NEW ELEMENTARY SCHOOL
9801 HIGHLAND KNOLLS DR
BAKERSFIELD CALIFORNIA 93306

FOR:
BAKERSFIELD CITY SCHOOL DISTRICT
1300 BAKER STREET
BAKERSFIELD CALIFORNIA 93305

COPYRIGHT: ORDIZ-MELBY ARCHITECTS, INC. 2010
SHEET TITLE: **ELECTRICAL PLAN BUILDING A**

SHEET IDENTIFICATION NUMBER: **E-121A**

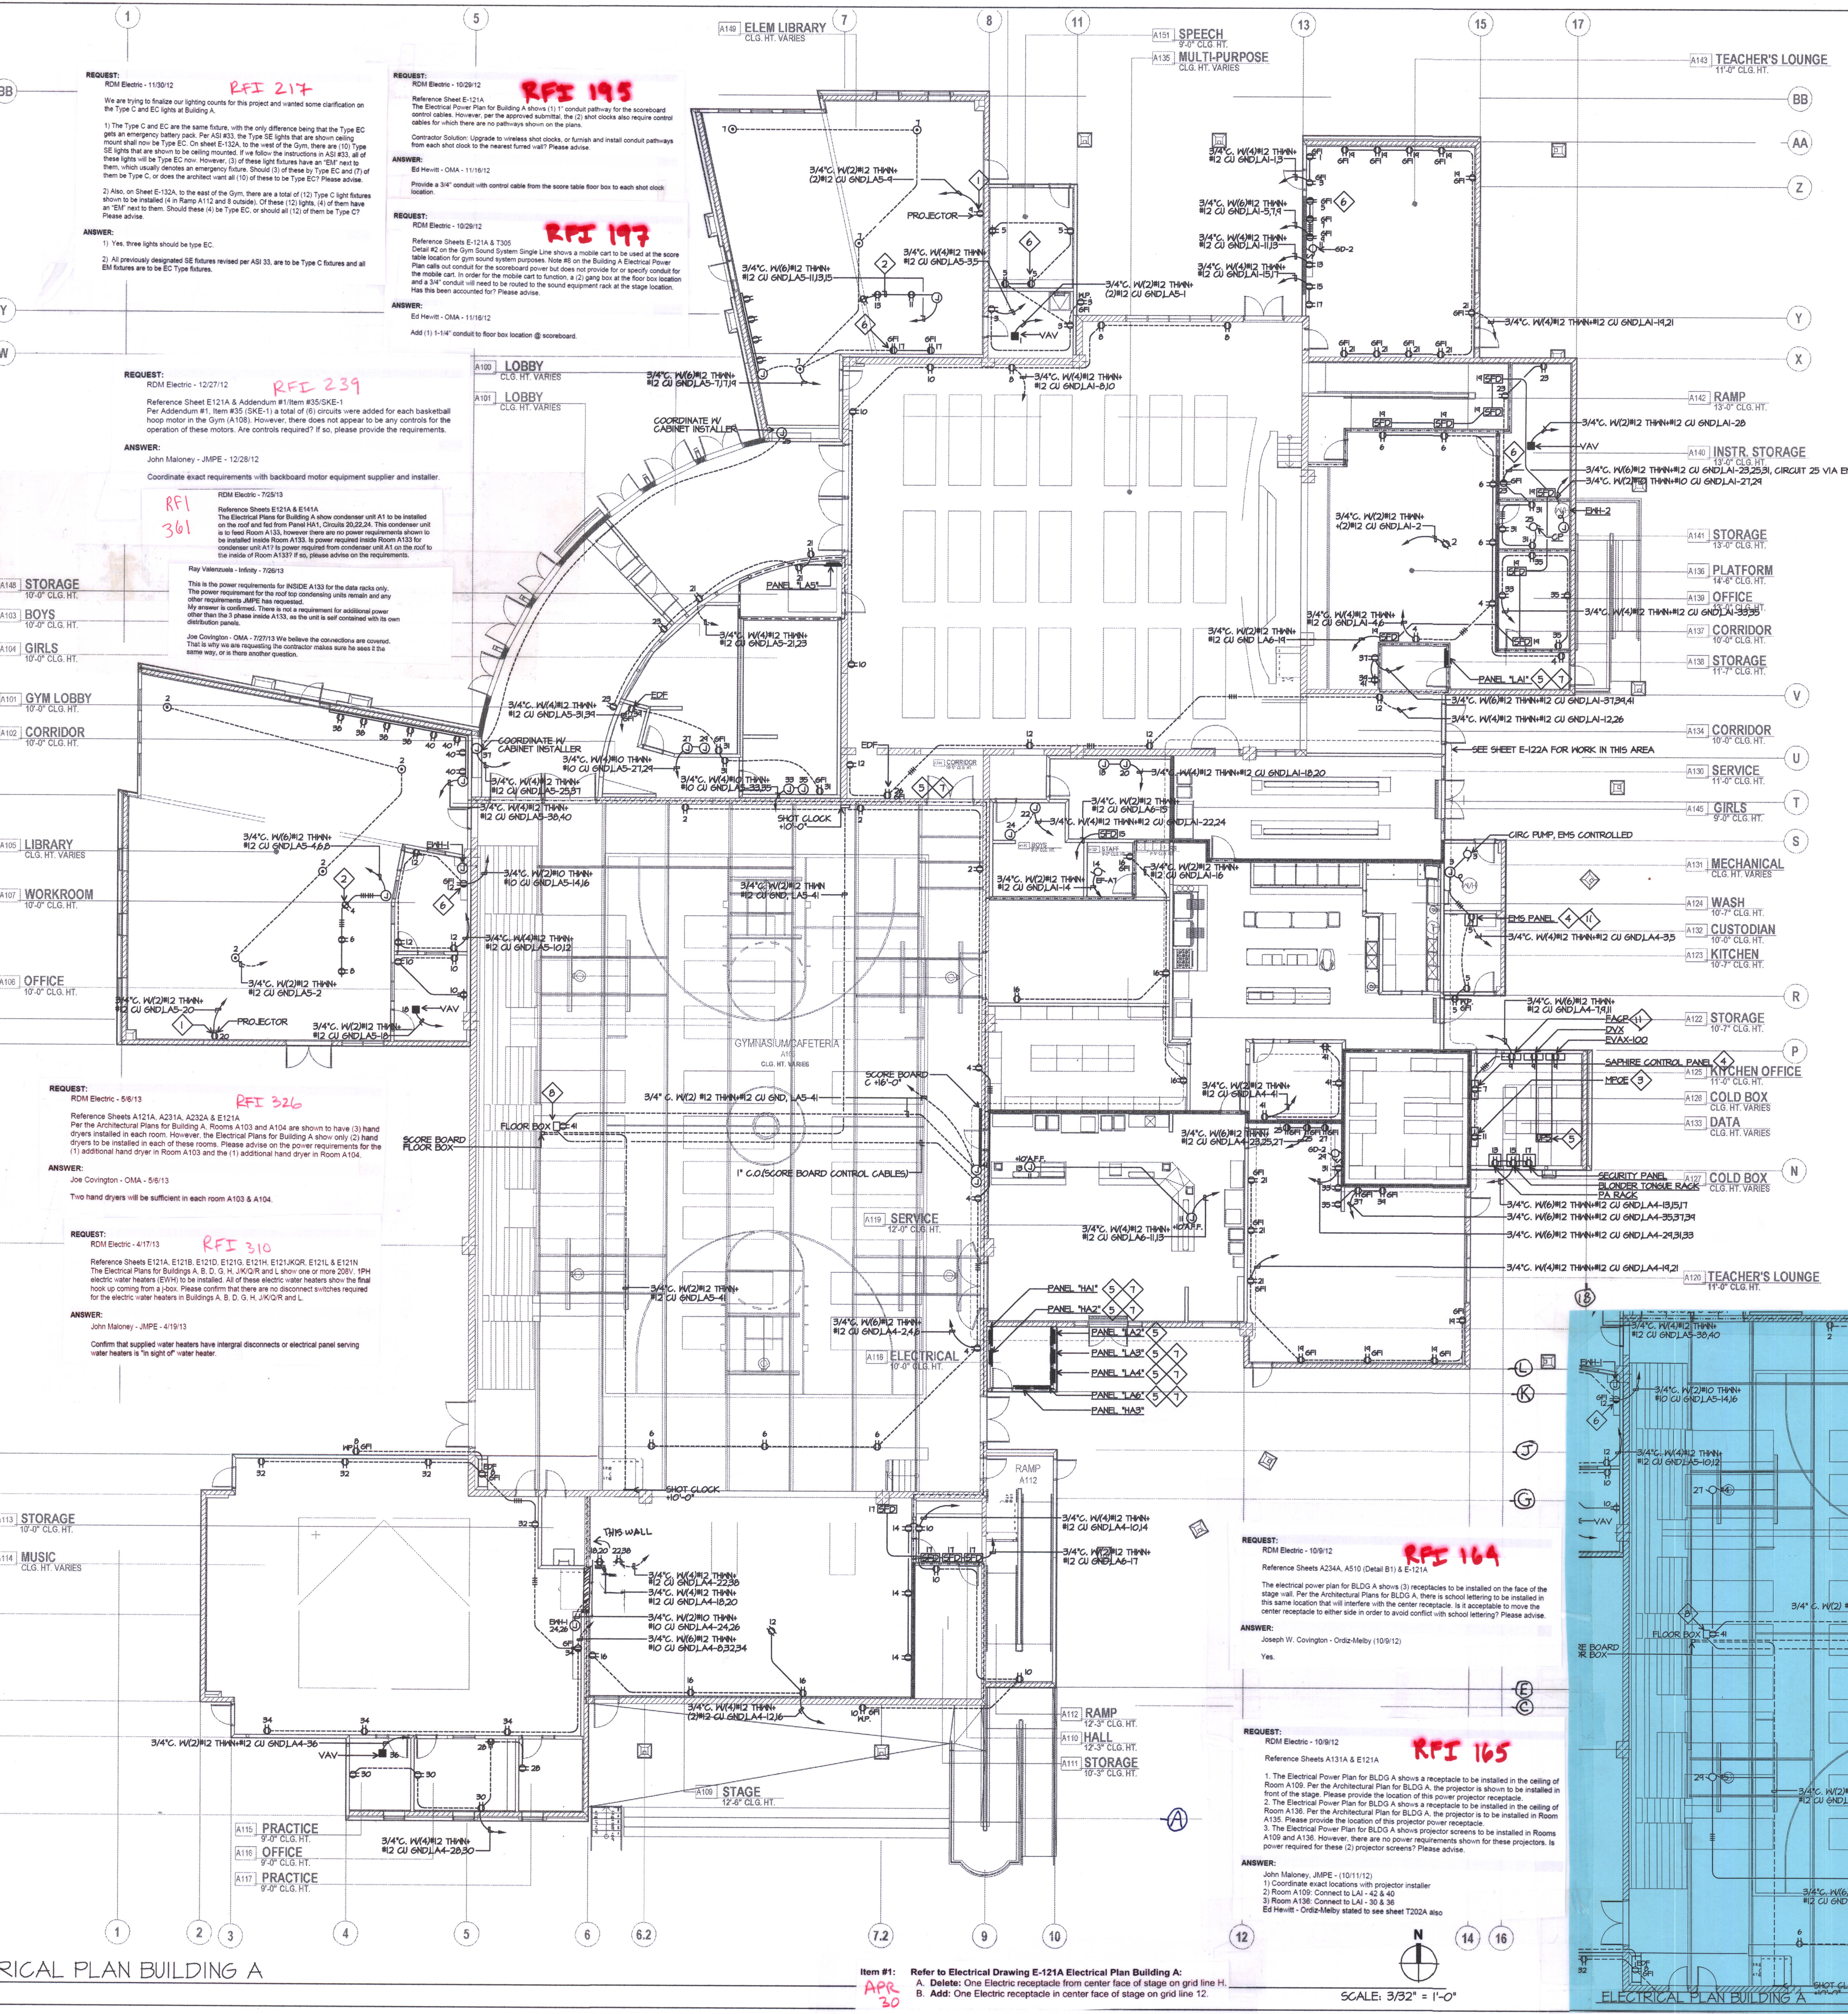
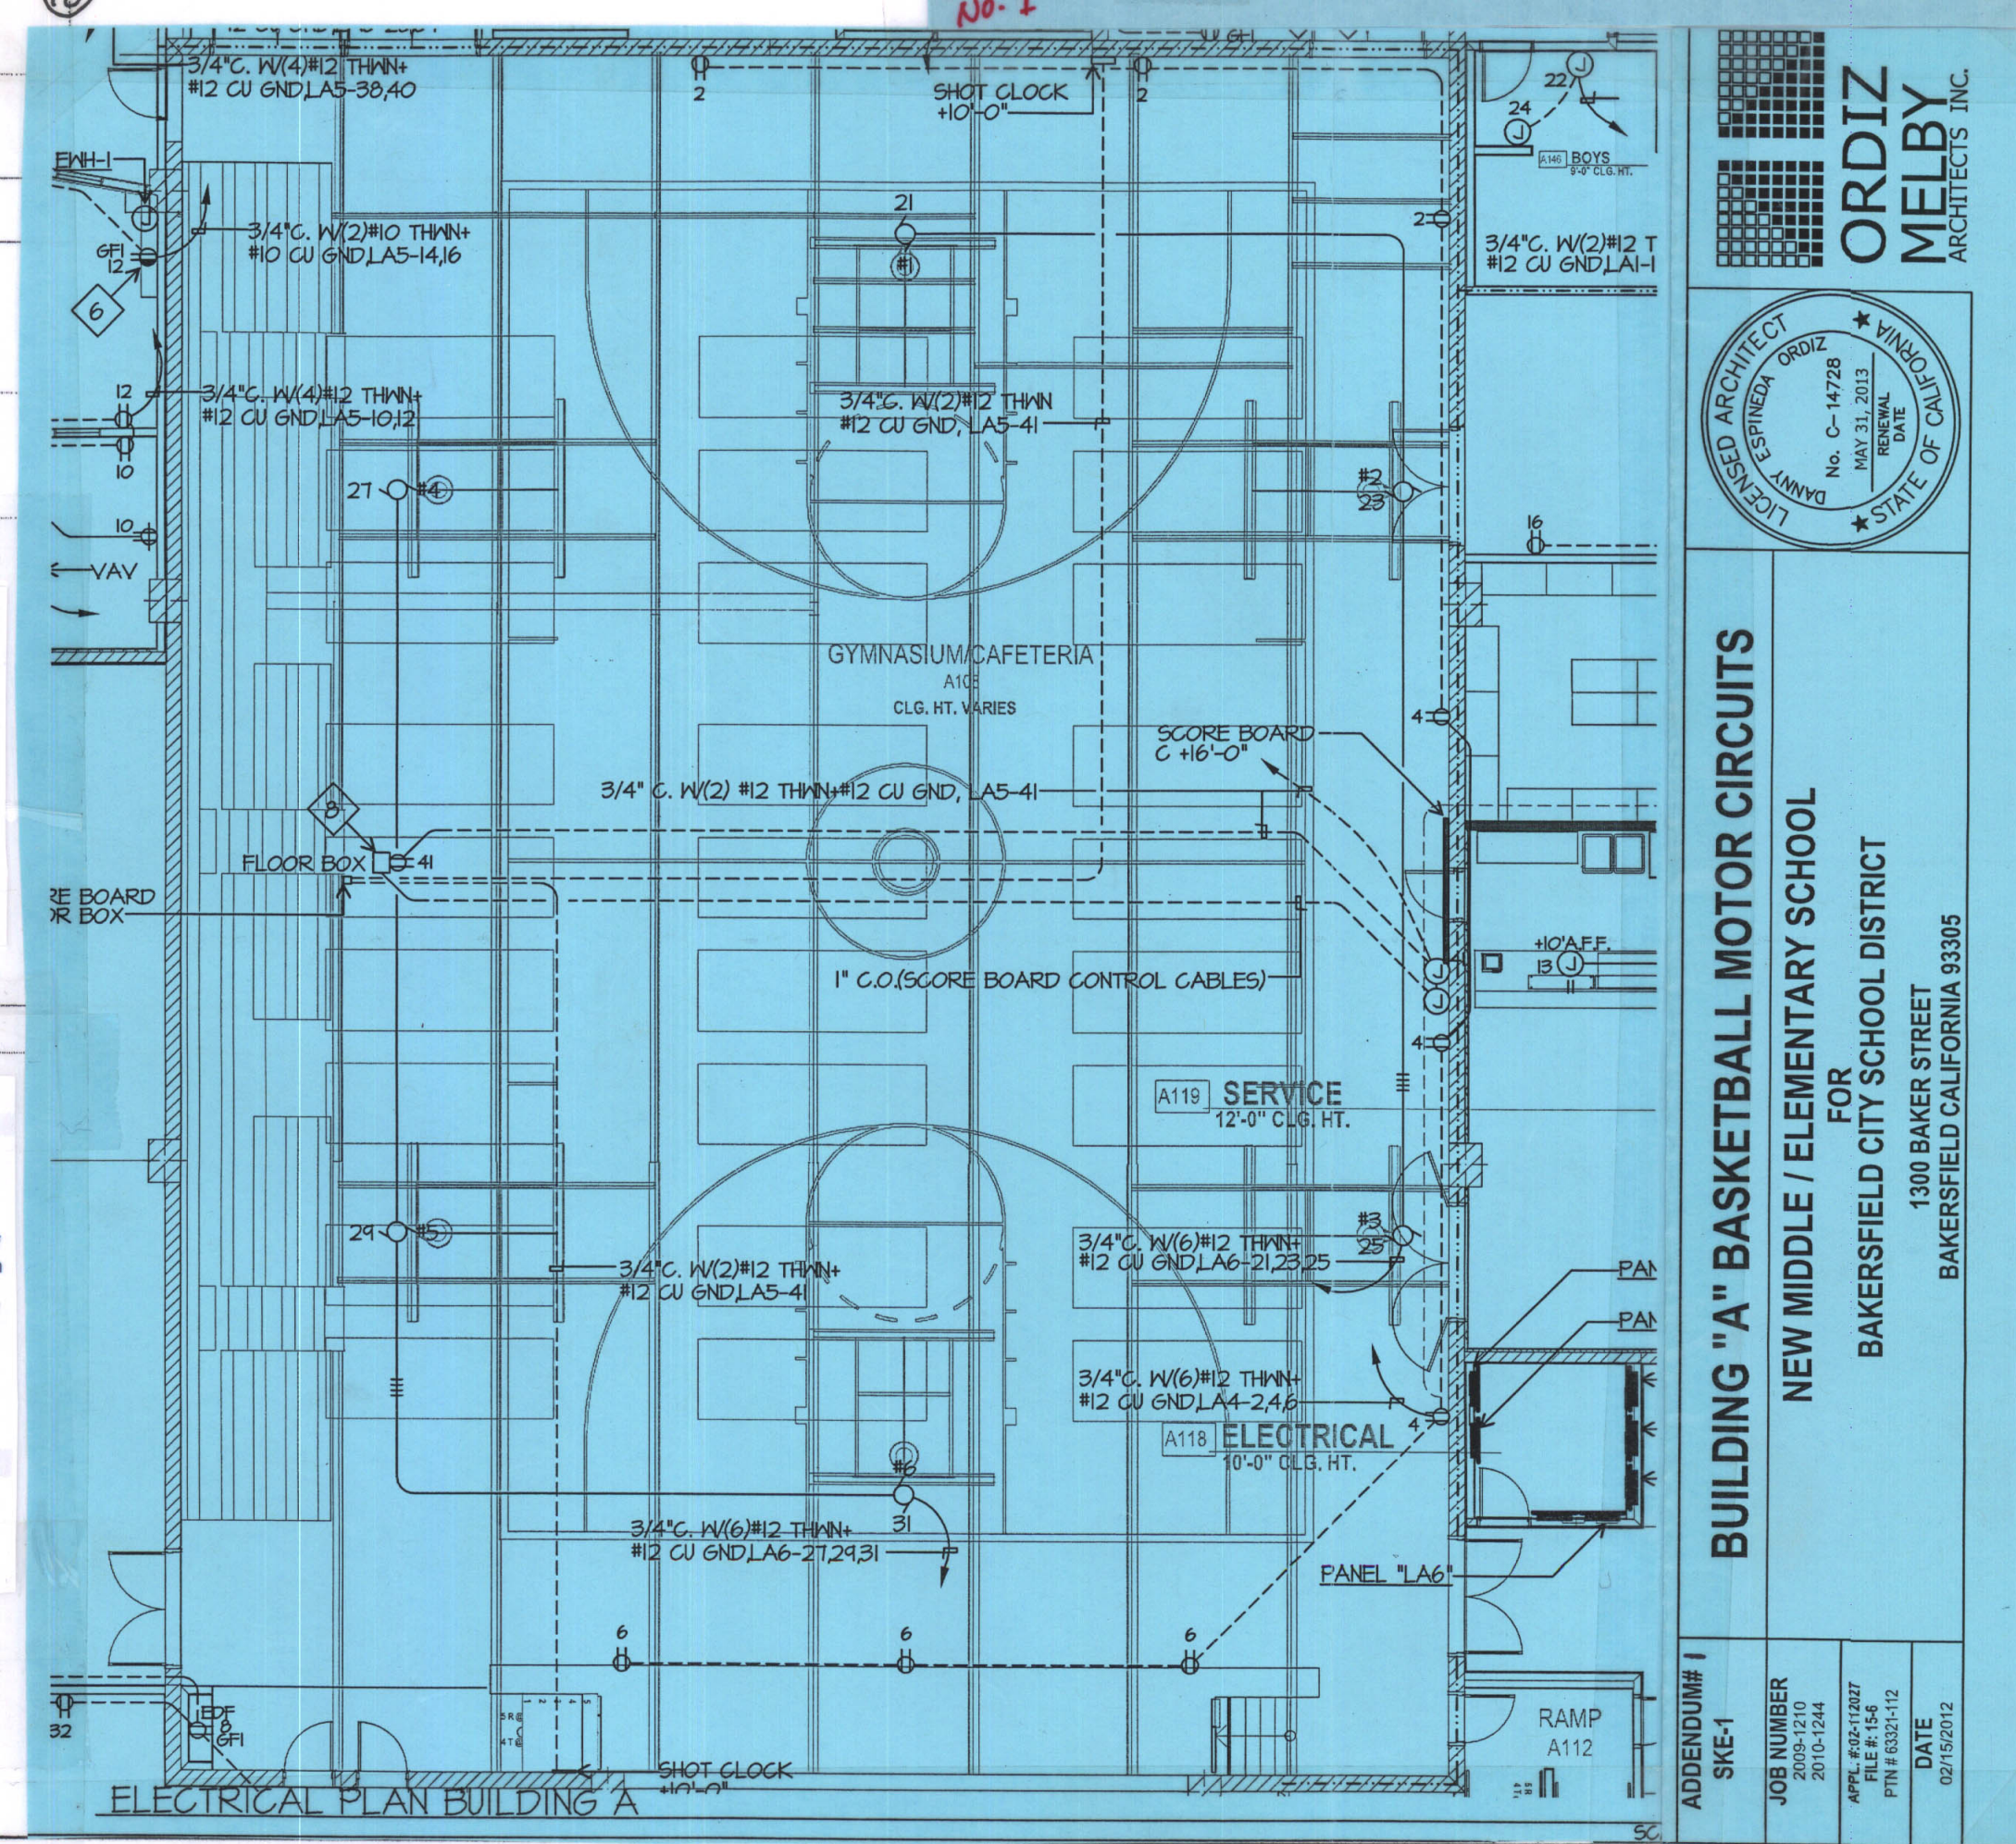
RFI 164
Request: RDM Electric - 10/9/12
Reference Sheets A234A, A510 (Detail B1) & E-121A
The electrical power plan for BLDG A shows (3) receptacles to be installed on the face of the stage wall. For the Architectural Plans for BLDG A, there is a school lettering to be installed in this same location that will interfere with the center receptacle. Is it acceptable to move the center receptacle to either side in order to avoid conflict with school lettering? Please advise.
Answer: Joseph W. Covington - Ordiz-Melby (10/9/12)
Yes.

RFI 67
Request: RDM Electric - 6/13/12
Reference Sheet E121A
The Electrical Plan for Building A shows a floor box on the west side of the Gymnasium (Room A109) with a note #8 pointing to it. Note #8 calls for a Cole Lighting Floor Box Model #FLS-353-8-MOD-JR-GRAYTOP. Just in front of the bleachers, there is another small symbol with a note pointing to it calling for a Cole "Score Board Floor Box". Please confirm that there is only (1) Cole Lighting Floor Box in this location.
Answer: YES. There will be only floor box for score board and shot clocks. It should be located approximately at center of main court - 60 feet south of G.L. T. and 12 feet east of G.L. S.

Item #28: Refer to Electrical Drawing E-121A.
A. UPDATE: Sheet E-A121 per attached drawing SK-1 to show circuiting for basketball motors.

RFI 217
Request: RDM Electric - 11/30/12
We are trying to finalize our lighting courts for this project and wanted some clarification on the Type C and EC lights at Building A.

1) The Type C and EC are the same fixture, with the only difference being that the Type EC must have an emergency battery pack. Per AS203, the Type SE lights that are shown ceiling grid lights shall now be Type EC. On sheet E-121A, to the west of the Gym, there are (10) Type EC lights that are shown to be ceiling mounted. If we follow the instructions in AS203, all of these lights will be Type EC now. However, (3) of these light fixtures have an "E" next to them, which usually denotes an emergency fixture. Should (3) of these Type EC and (7) of them be Type C, or does the architect want all (10) of these to be Type EC? Please advise.

2) Also, on Sheet E-121A, to the east of the Gym, there are a total of (12) Type C light fixtures shown to be installed in Ramp A112 and (8) outside. Of these (12) lights, (4) of them have an "E" next to them. Should these (4) be Type EC, or should all (12) of them be Type C? Please advise.

RFI 195
Request: RDM Electric - 10/28/12
Reference Sheet E-121A
The Electrical Power Plan for Building A shows (1) 1" conduit pathway for the scoreboard control cables. However, per the approved submittal, the (2) shot clocks also require control cables for which there are no pathways shown on the plans.
Contractor Solution: Upgrade to wireless shot clocks, or furnish and install conduit pathways from each shot clock to the nearest nearest wall. Please advise.
Answer: Ed Hewitt - OMA - 11/16/12
Provide a 3/4" conduit with control cable from the score table floor box to each shot clock location.

RFI 197
Request: RDM Electric - 10/28/12
Reference Sheets E-121A & T306
Detail #2 on the Gym Sound System Single Line shows a middle cart to be used at the score table location for gym sound system purposes. Note #8 on the Building A Electrical Power Plan calls out conduit for the scoreboard power but does not provide for a speaker, conduit for the middle cart, in order for the middle cart to function. (2) gang bars at the floor box location and a 3/4" conduit will need to be routed to the sound equipment rack at the stage location. Has this been accounted for? Please advise.
Answer: Ed Hewitt - OMA - 11/16/12
Add (1) 1-1/4" conduit to floor box location @ scoreboard.

RFI 239
Request: RDM Electric - 12/27/12
Reference Sheet E121A & Addendum #1 Item #35 (SKE-1)
Per Addendum #1, Item #35 (SKE-1) a total of (6) circuits were added for each basketball hoop motor in the Gym (A109). However, there does not appear to be any controls for the operation of these motors. Are controls required? If so, please provide the requirements.
Answer: John Maloney - JMPE - 12/28/12
Coordinate exact requirements with scoreboard motor supplier and installer.

RFI 361
Request: RDM Electric - 7/26/13
Reference Sheets E121A & E141A
The Electrical Plans for Building A show condenser unit A11 to be installed on the roof and for Panel A11, Circuits 20,22,24. This condenser unit is to be installed inside Room A133. In power required inside Room A133 for condenser unit A11 power required from condenser unit A11 on the roof to the inside of Room A133? If so, please advise on the requirements.
Ray Venetovels - Infirly - 7/26/13
This is the power requirements for INSIDE A133 for the data racks only. The power requirements for the not just conditioning units remain and only other requirements JMPE has requested. My answer is correct. There is no requirement for additional power other than the 3 phase inside A133, as the unit is self contained with its own distribution panel.
Joe Covington - OMA - 7/27/13 We believe the connections are correct. That is why we are requesting the contractor make sure he sees it the right way at or from another position.

RFI 326
Request: RDM Electric - 5/9/13
Reference Sheets A121A, A231A, A232A & E121A
Per the Architectural Plans for Building A, Rooms A103 and A104 are shown to have (3) hand dryers installed in each room. However, the Electrical Plans for Building A show only (2) hand dryers to be installed in each of these rooms. Please advise on the power requirements for the (1) additional hand dryer in Room A103 and the (1) additional hand dryer in Room A104.
Answer: Joe Covington - OMA - 5/9/13
Two hand dryers will be sufficient in each room A103 & A104.

RFI 310
Request: RDM Electric - 4/17/13
Reference Sheets E121A, E121B, E121C, E121D, E121E, E121F, E121G, E121H, E121I, E121J, E121K, E121L, E121M, E121N
The Electrical Plans for Building A, B, D, G, H, J, K, Q, R and L show one or more 208V, 1PH electric water heaters (EWH) to be installed. All of these electric water heaters show the final floor up controls from a pool. Please confirm that there are no disconnect switches required for the electric water heaters in Buildings A, B, D, G, H, J, K, Q, R and L.
Answer: John Maloney - JMPE - 4/19/13
Confirm that supplied water heaters have integral disconnects or electrical panel serving water heaters is "in sight" of water heater.

RFI 165
Request: RDM Electric - 10/9/12
Reference Sheets A131A & E121A
1. The Electrical Power Plan for BLDG A shows a receptacle to be installed in the ceiling of Room A109. Per the Architectural Plan for BLDG A, the projector is shown to be installed in front of the stage. Please provide the location of this projector receptacle.

2. The Electrical Power Plan for BLDG A shows a receptacle to be installed in the ceiling of Room A136. Per the Architectural Plan for BLDG A, the projector is to be installed in Room A136. Please provide the location of this projector receptacle.

3. The Electrical Power Plan for BLDG A shows projector screens to be installed in Rooms A109 and A136. However, there are no power requirements shown for these projectors. Is power required for these (2) projector screens? Please advise.

Answer: 1) Yes, three lights should be Type EC.
2) All previously designated SE fixtures revised per AS 203, are to be Type C fixtures and all EM fixtures are to be EC Type fixtures.

Answer: John Maloney, JMPE - (10/11/12)
1. Coordinate exact locations with projector installer.
2. Room A109: Connect to LAI - 42 & 40
3. Room A136: Connect to LAI - 30 & 36
Ed Hewitt - Ordiz-Melby stated to see sheet T302A also
